Work Order ID 119586

Item Name: Crosstube Turning Detail

DART AEROSPACE LTD		Work Order:	119586
Description: Crosstube Assembly (205/212/412 High Fwd)		Part Number:	D212-664-141
Inspection Dwg: D212-664-141 Rev: D		Page 1 of 2

DRAWING NO. D212-664-141	TITLE XTUBE ASSY (205/212/412 HI FWD)	REV. D	DART AEROSPACE LTD ENGINEERING ORDER		D.E.O. NO. D212-664-141-D-1	SHEET NO. SHEET 1 OF 2	SCALE NTS
DRAWN	CHECKED <i>UP</i>	MFG. APPR. <i>EE</i>	APPROVED <i>MAP</i>		DE APPR. <i>TH</i>		
DATE 11.04.07	DATE 11.04.11	DATE 11.04.12	DATE 11/04/12		DATE 11.04.12

**D212-664-141/-141B
ASSEMBLY DETAIL**

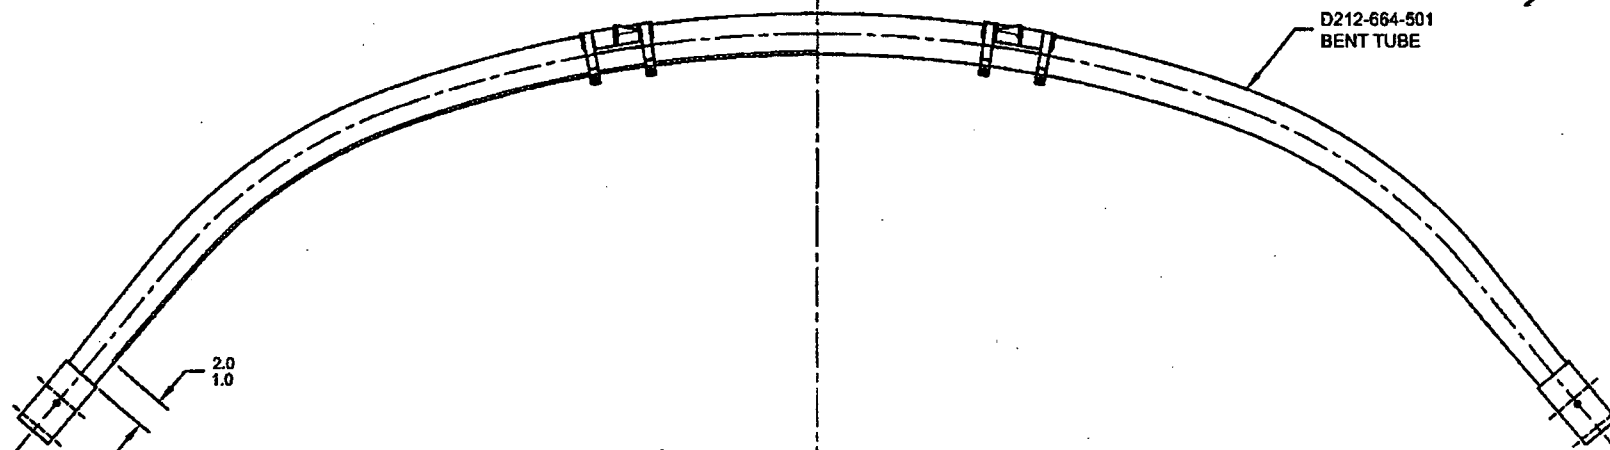
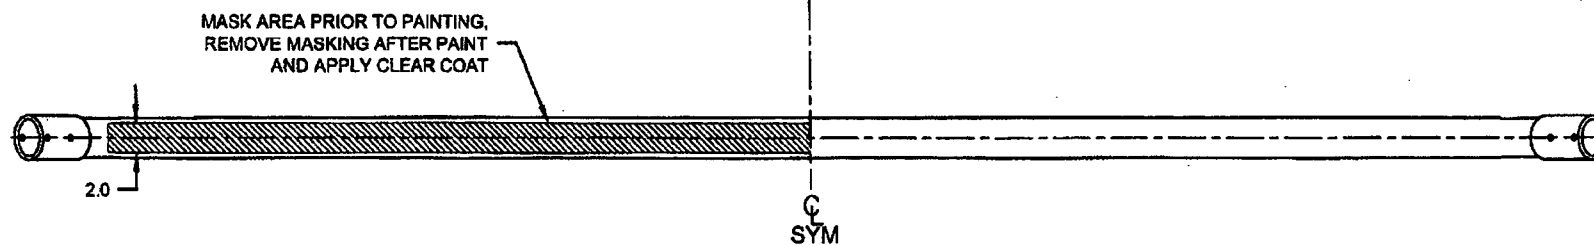
PURPOSE:

ADD AN INSPECTION WINDOW TO UNDERSIDE OF CROSSTUBE.

NOTES 2 OF SHEET 1 IS AMENDED AS FOLLOWS:

IS:

WAS:

- 2) FINISH: CHEMICAL CONVERSION COAT PER DART QSI 005 4.1
PRIME INSIDE AND OUTSIDE PER DART QSI 005 4.2
MASK UNDERSIDE OF CROSSTUBE AS SHOWN (HATCHED AREA) AND
PAINT OUTSIDE PER DART QSI 005 4.2
REMOVE MASKING AND APPLY CLEAR COAT
